Mixed Industry and Business Development – 101 Wongawallan Drive, Yarrabilba RFI Response

Lot 27 Wongawallan Drive, Yarrabilba
Swept Path Assessment

AMENDED IN RED

DWG NO: 1624 S04/

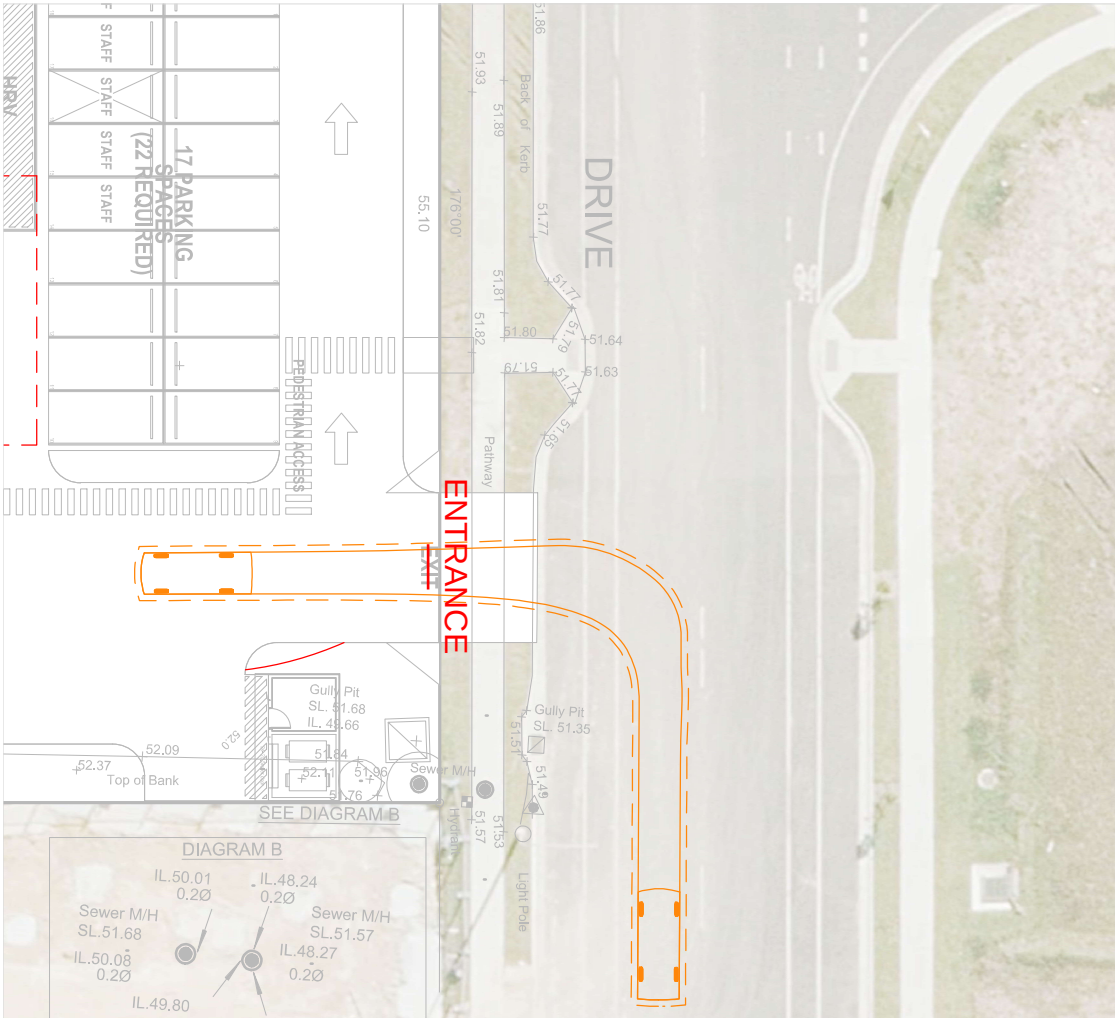
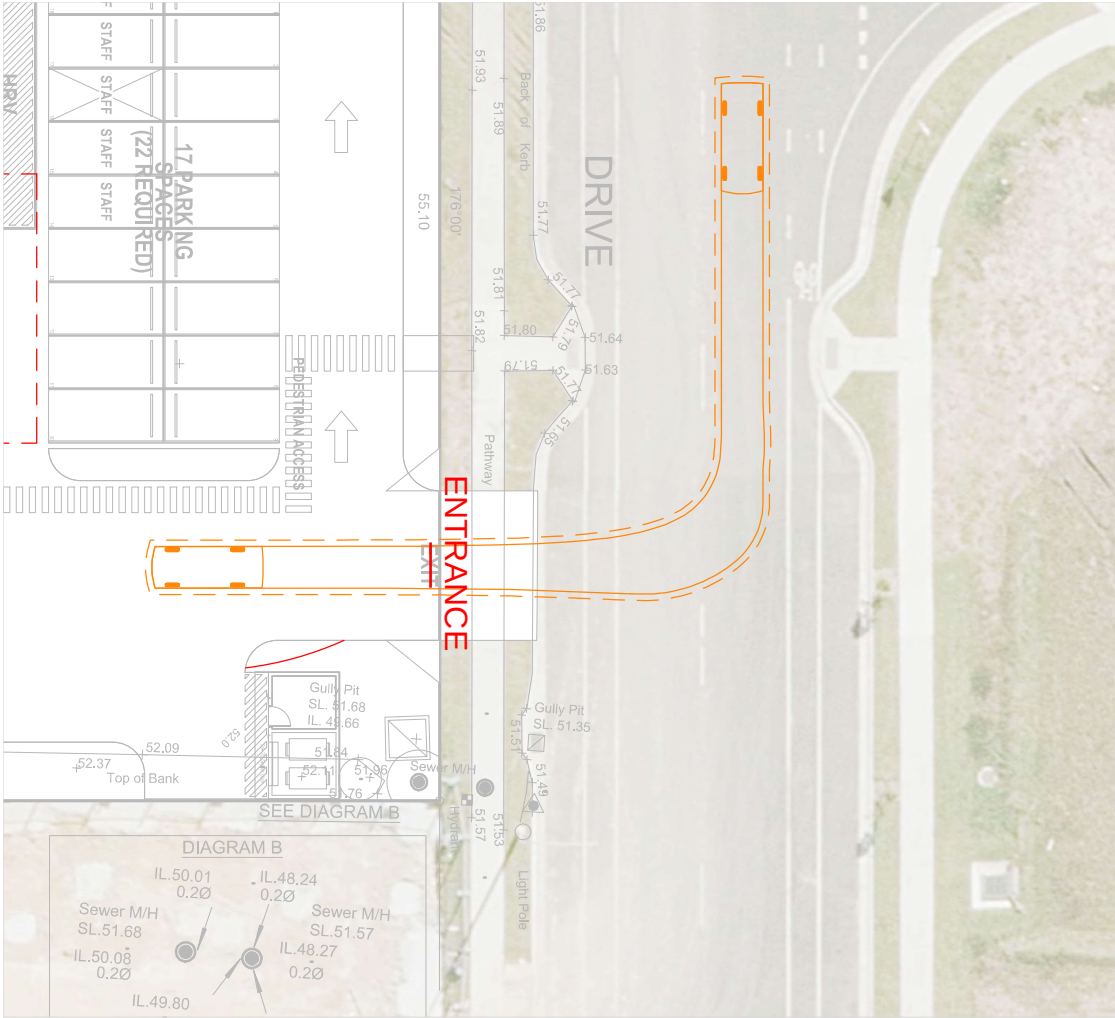
Suggest adding right arrows as well, as this aisle can accommodate two-way vehicle movement.

EXIT
~~ENTRY~~

ENTRANCE
~~EXIT~~

- Suggest cutting back landscaping to allow for HRV movements. Minimum extent required indicated in red.

Can add more landscaping here (refer Sheet 13)

- Mirror HRV standing bay and staff allocated spaces

Entry and exit crossovers to be swapped

Amber 01

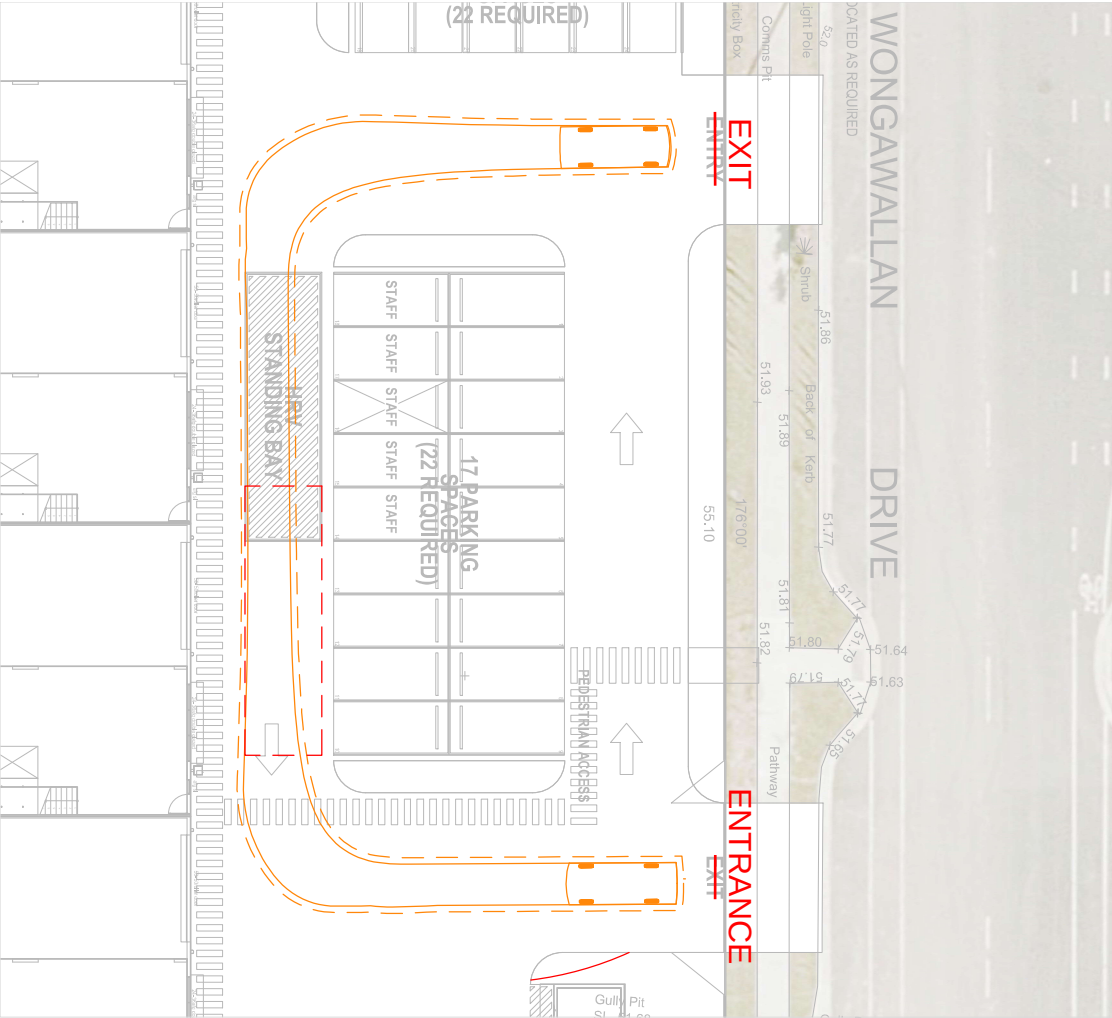
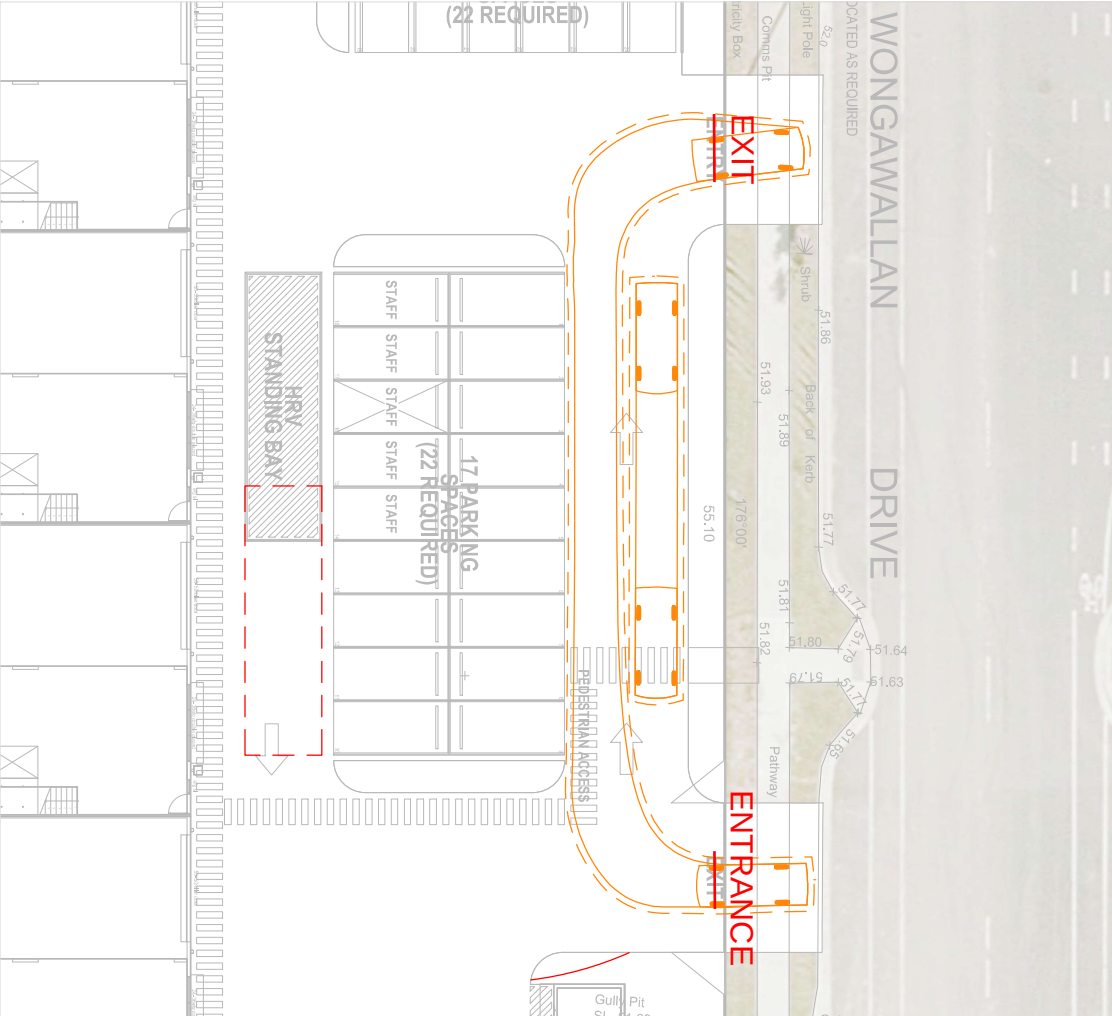
Entry and exit crossovers to be swapped

Amber 02

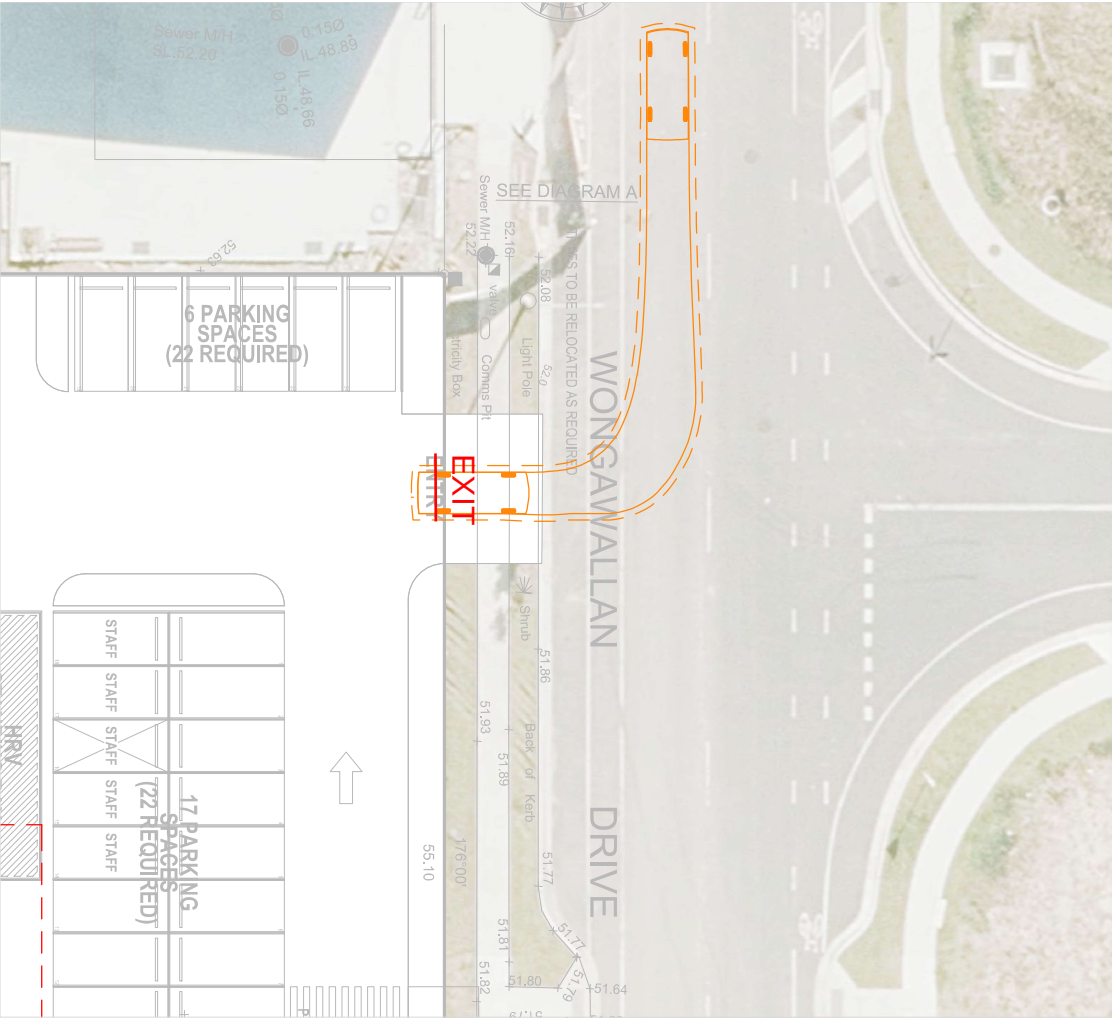
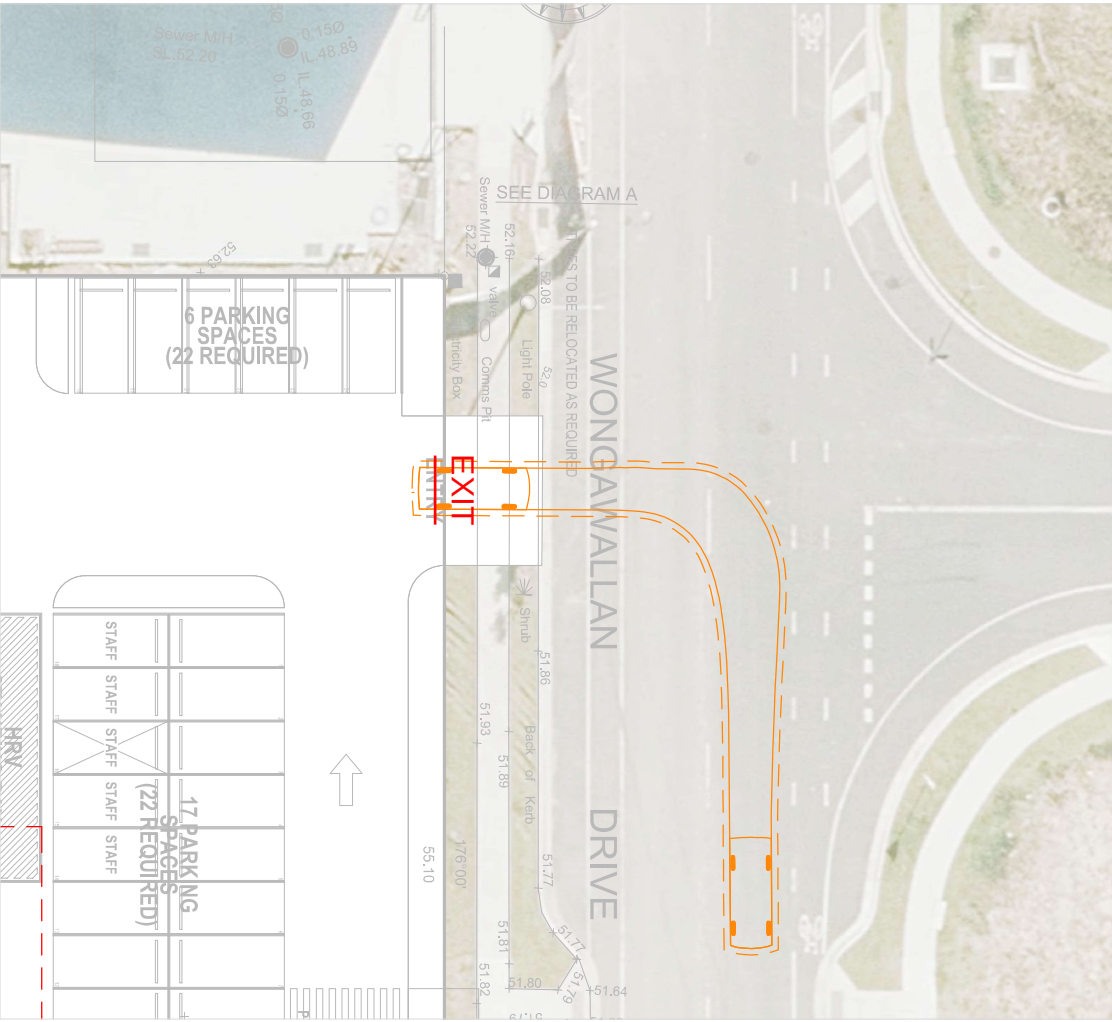
Entry and exit crossovers to be swapped

DRAWN: RK
DATE: 02/07/2026
DWG NO: 1624 S04A
SCALE at A3: 1:250

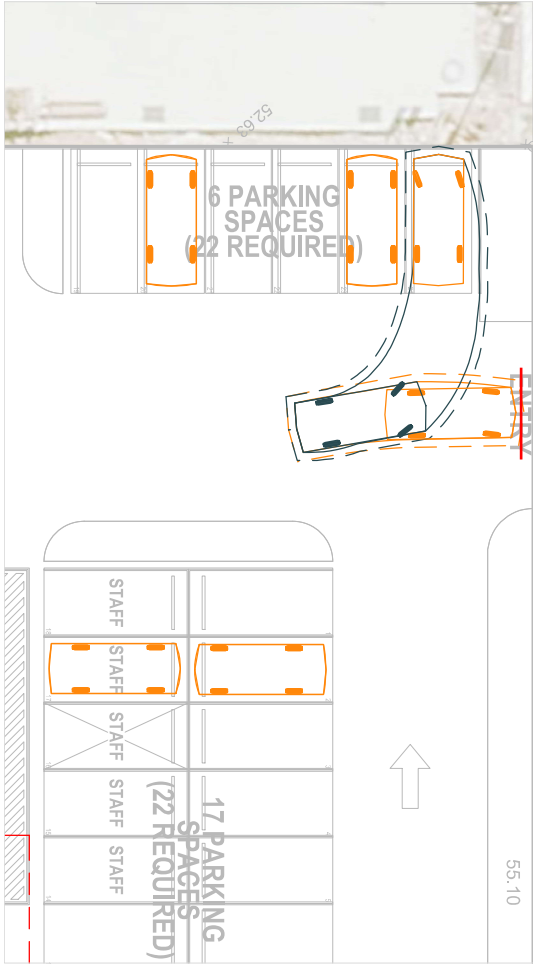
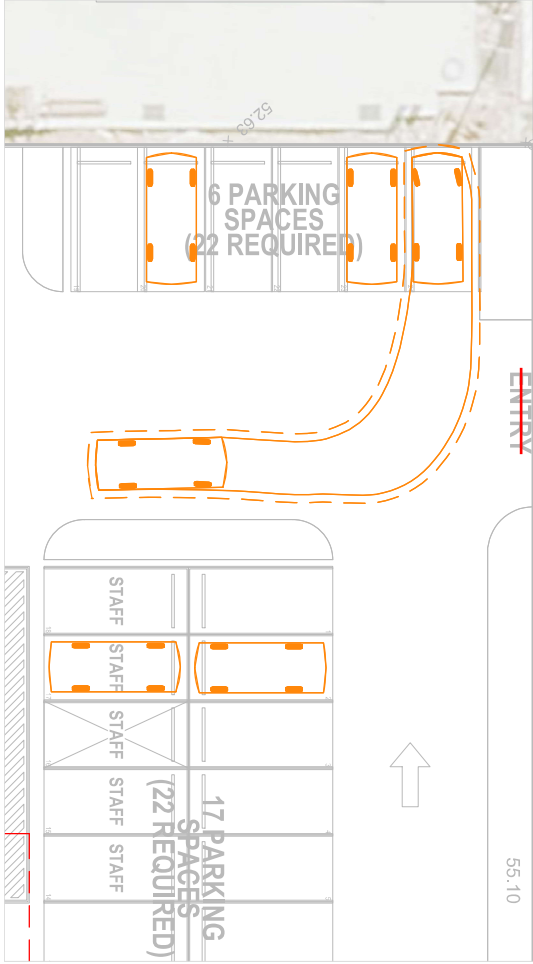
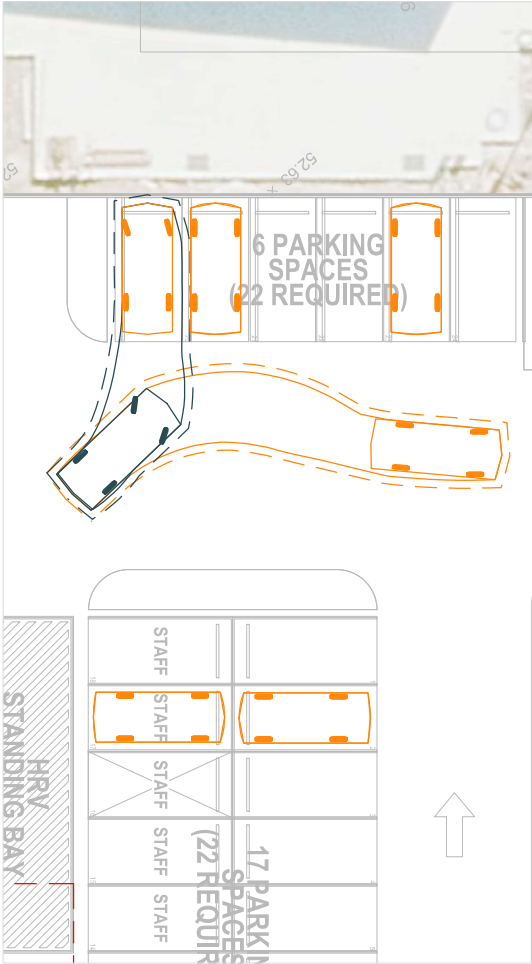
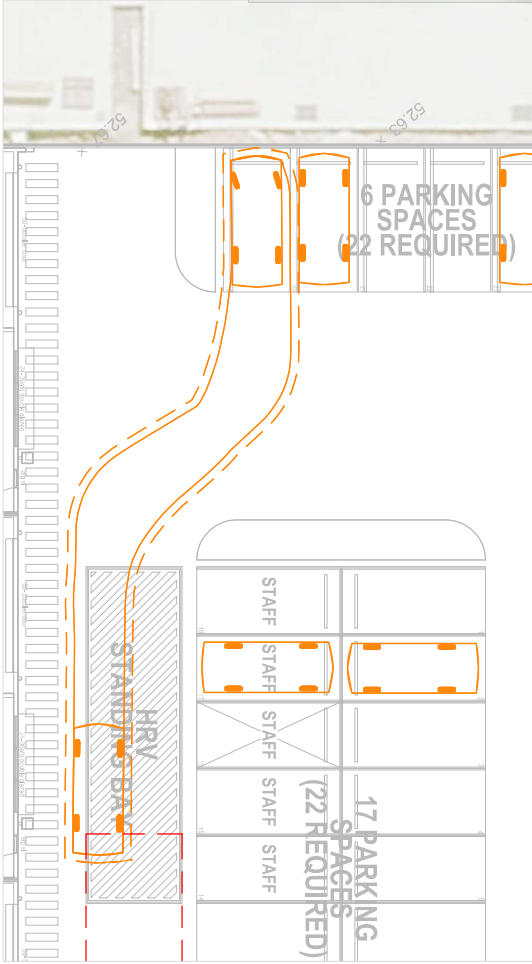
Entry and exit crossovers to be swapped

Amber 04

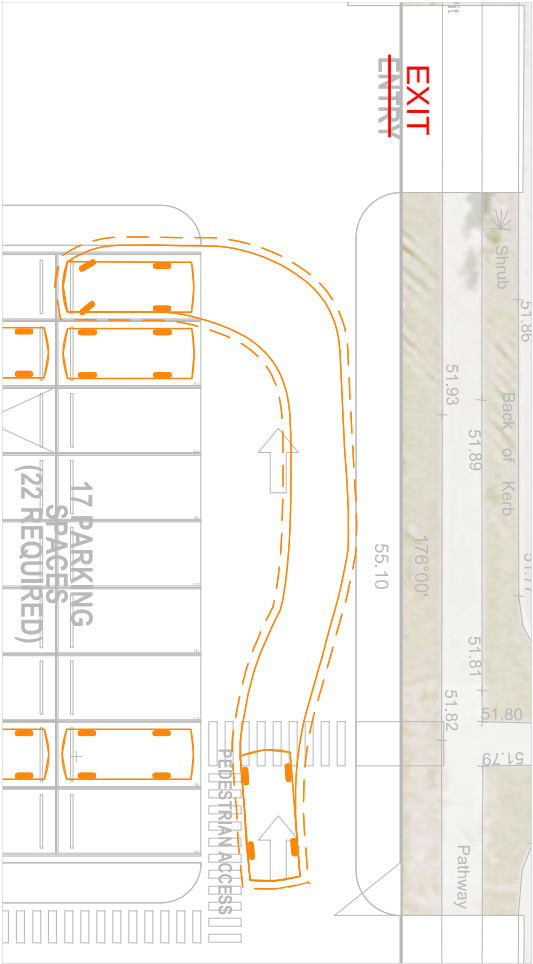
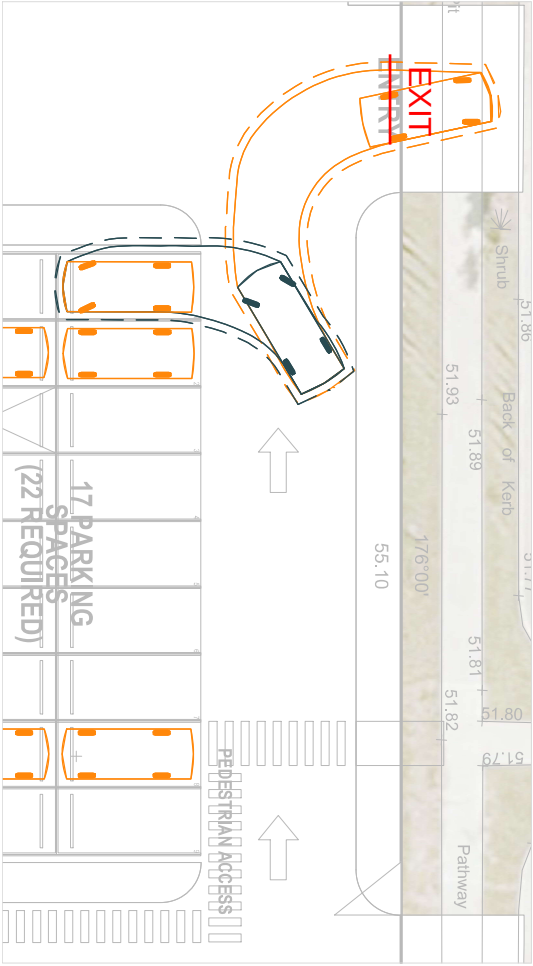
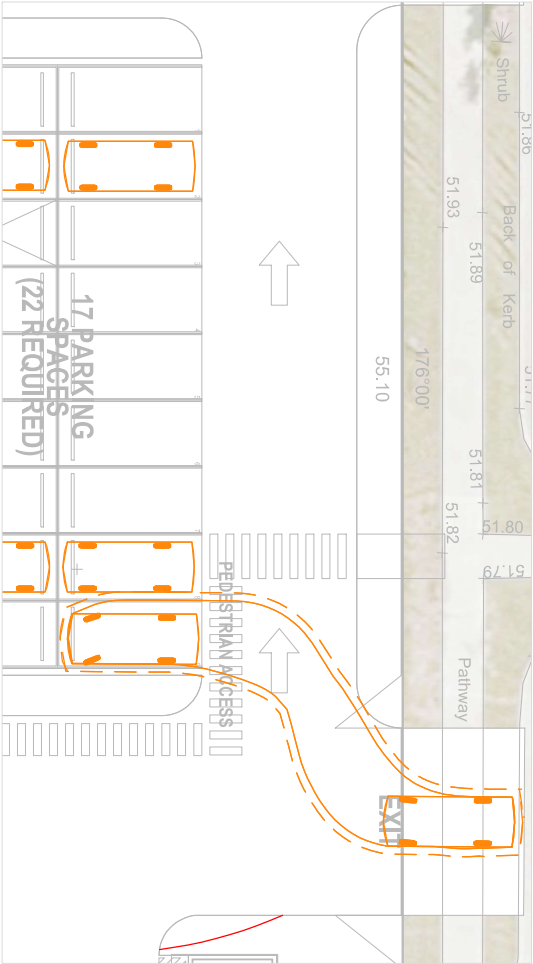
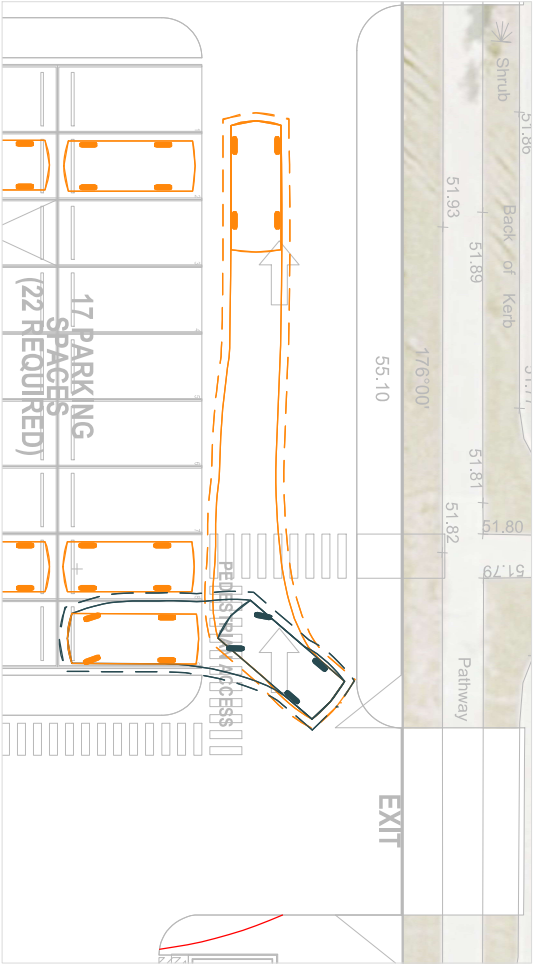
Entry and exit crossovers to be swapped
